MOT Session 2022 Construction Academy

Process Review Findings

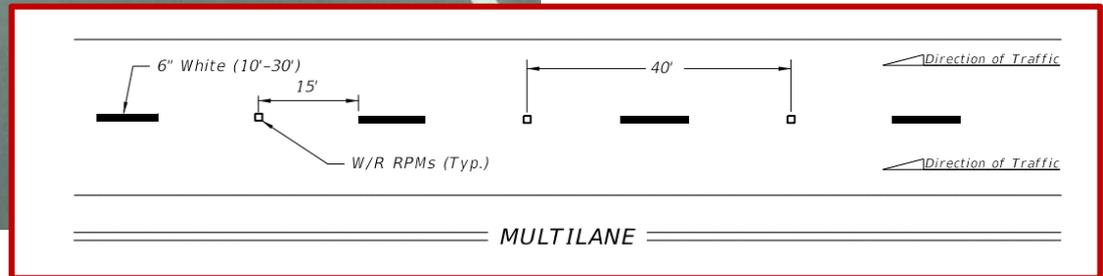
Type III barricades were not properly maintained.

Specification 102-9.1 requires all temporary traffic control devices to meet Acceptable standards as outlined in the ATSSA's Quality Guidelines for Temporary Traffic Control Devices and Features.

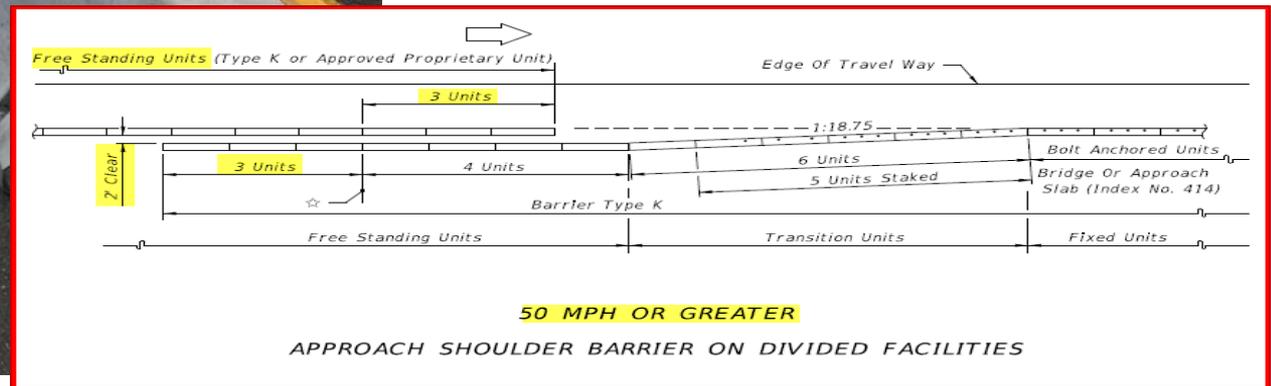
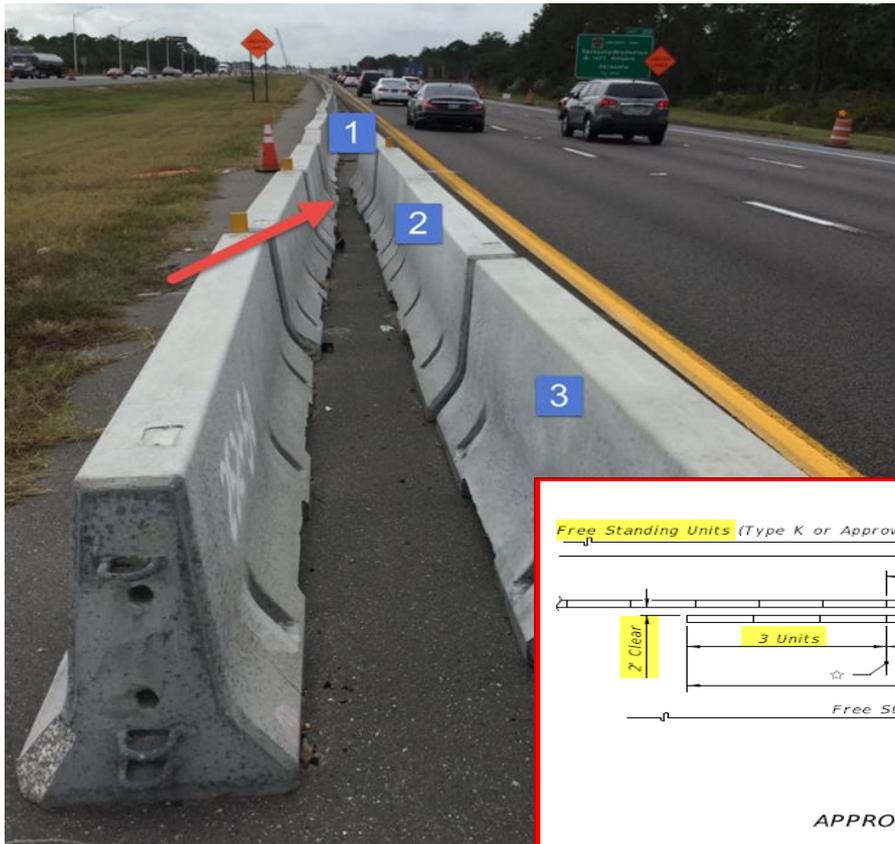
Pedestrian walkway was not properly detoured and Ped LCDs were not properly maintained.

Index 102-660 and ADA Guidelines require all temporary walkway surfaces be accessible with firm, stable, slip resistant and kept free of obstructions. Spec 102-9.5.2 also requires joints between Ped LCDs must a maximum offset of 1/2 inch in any one plane.

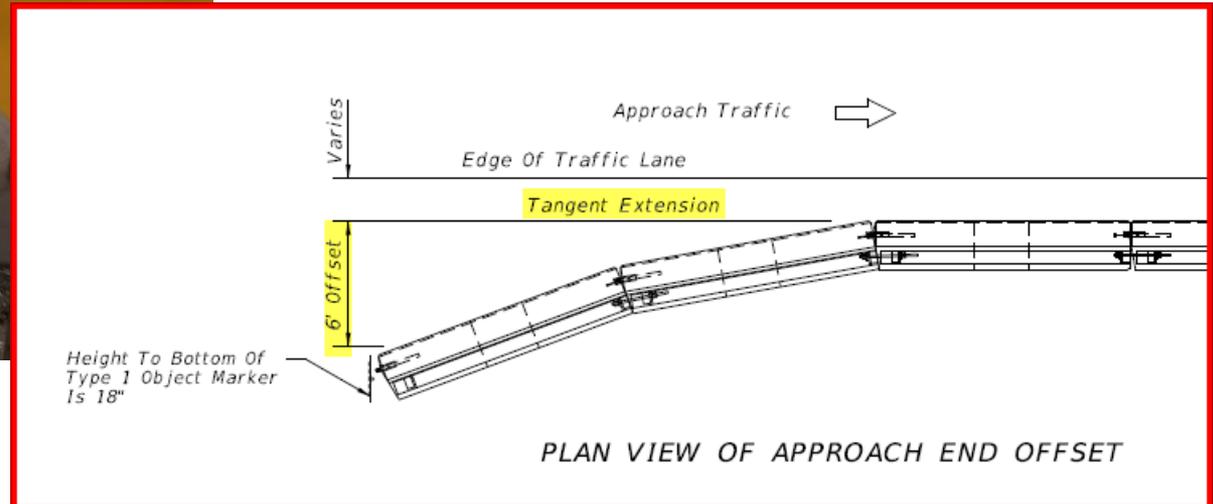
Construction debris, stockpiled material and other objects within deflection space of Type K barrier. Index 102-100, Sheet 1 requires the deflection space to be clear of any grass, construction debris, stockpiled materials, equipment and objects.

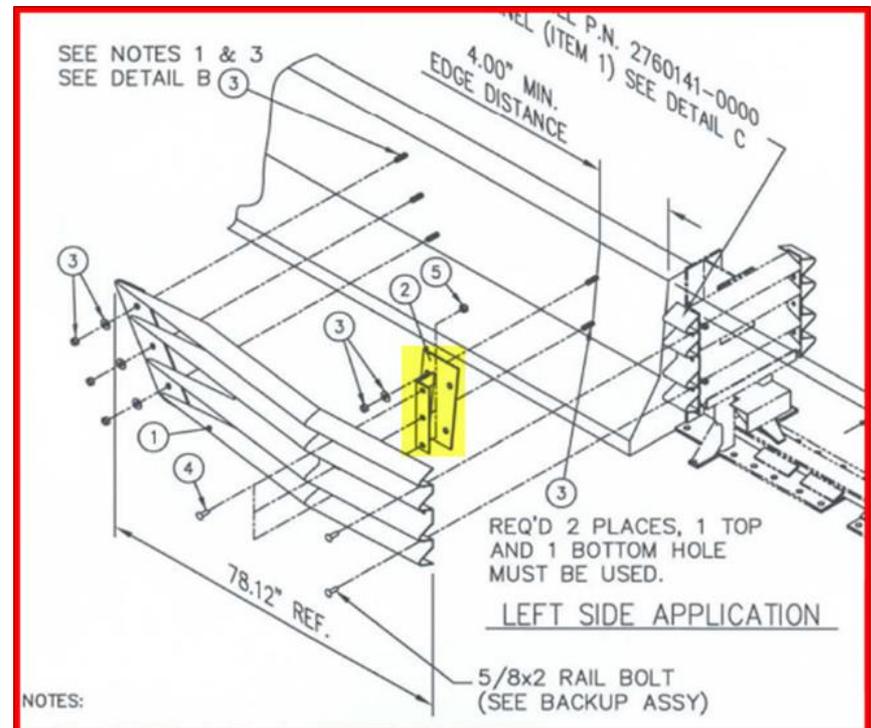
Crash cushion bracket support for the transition panel was missing. Vendor drawings require bracket support for transition panels (see screenshot below).

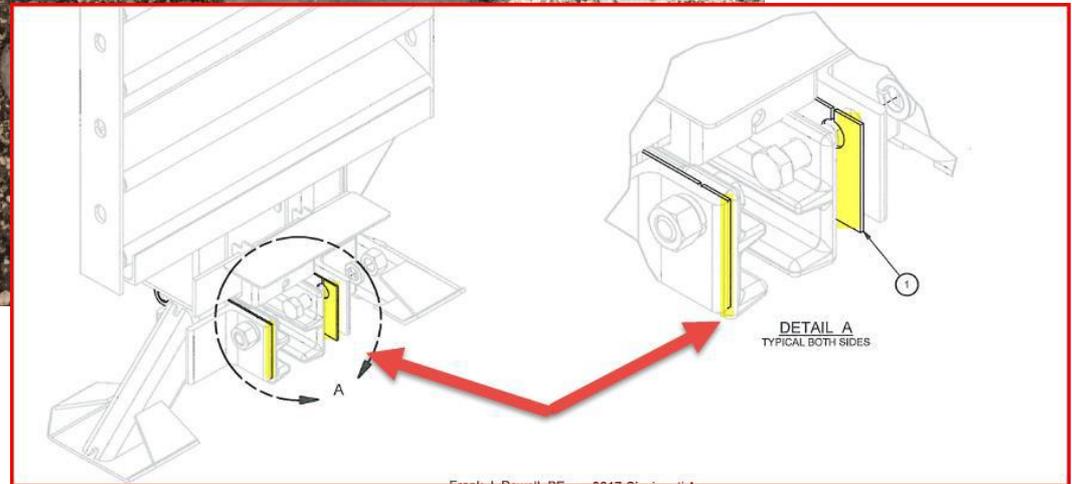
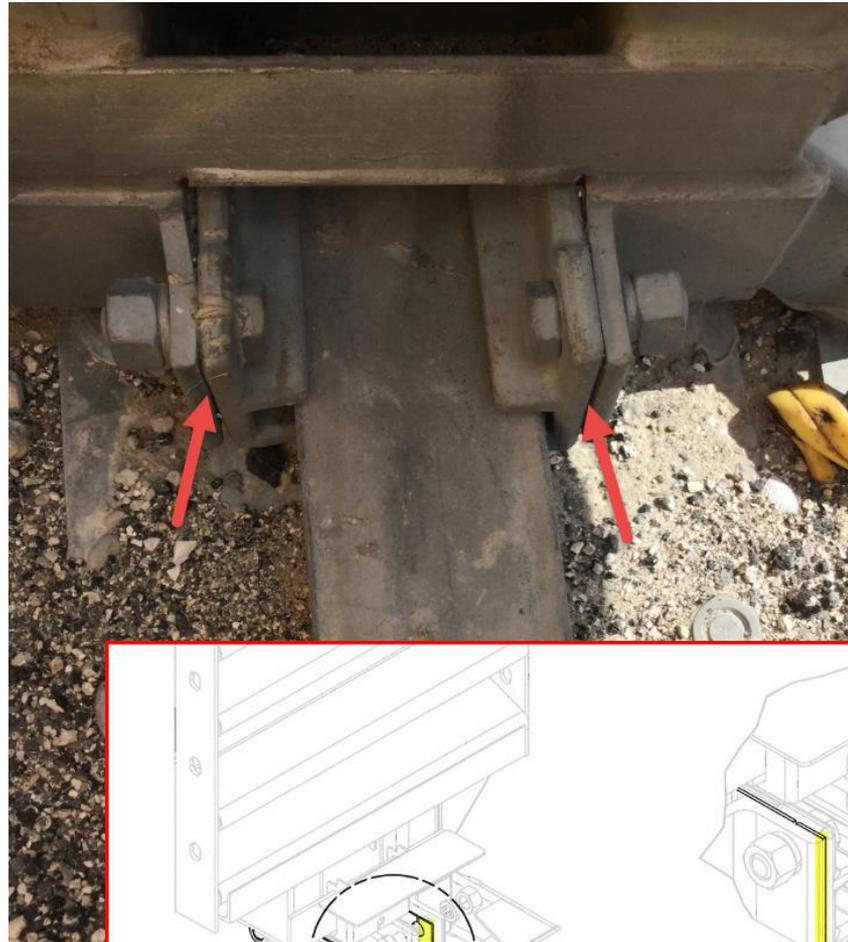
TRACC crash cushion had several loose nuts. Manufacturer's vendor drawings require all nuts be snug tight.

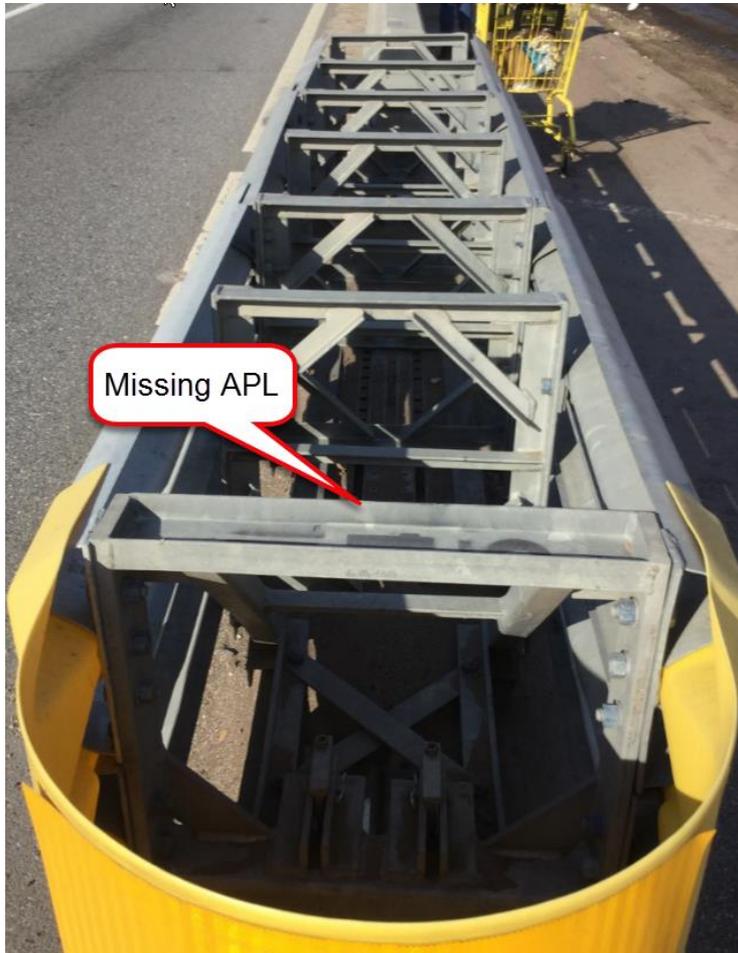
Anchor was installed on the backside of the barrier abutting crash cushion.

Index 102-110 requires anchors to be installed on traffic side.
